New Model Introduction

New model GR-4300-070 is offered as a replacement for model GR-115V. Models have common mounting and tooling and are dimensionally the same except as shown.

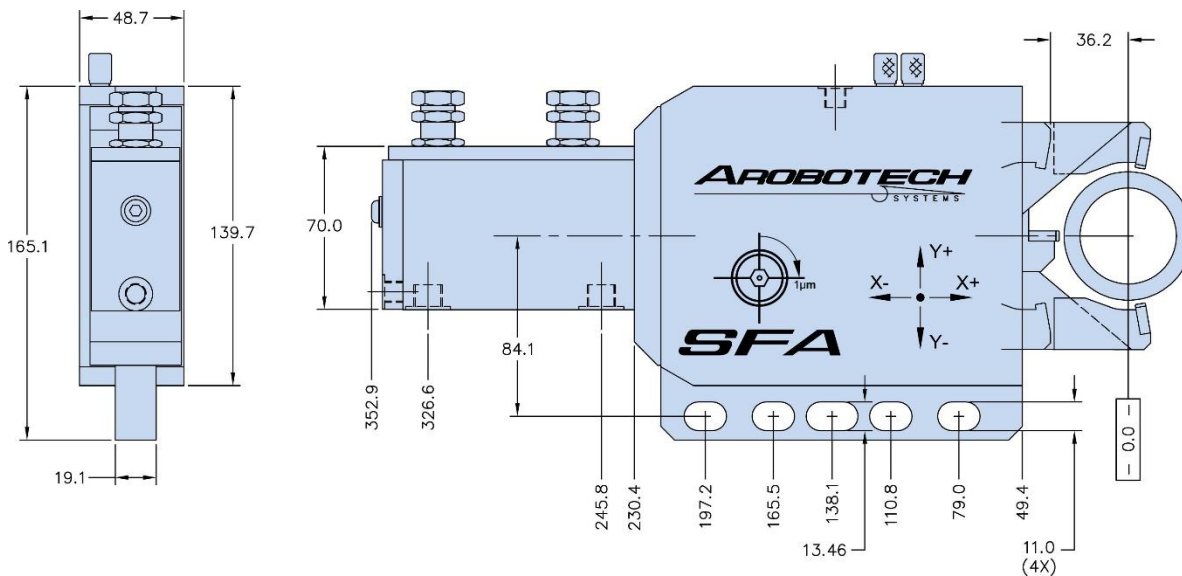
Gen 4 Model GR-115V

- * 15 to 60mm Diameter
- * 6.4 cm² Piston Area
- * X-Axis = 3.1° Turn = 0.001mm Adjustment ▪ ±0.22mm Total Adjustment
- * Y-Axis = 10.4° Turn = 0.001mm Adjustment ▪ ±0.07mm Total Adjustment

Gen 5 Model GR-4300-000

- * 15 to 60mm Diameter
- * 6.4 cm² Piston Area
- * 90° Turn = 0.001mm Adjustment (both axis)
- * +/- 0.200mm Total Adjustment (both axis)
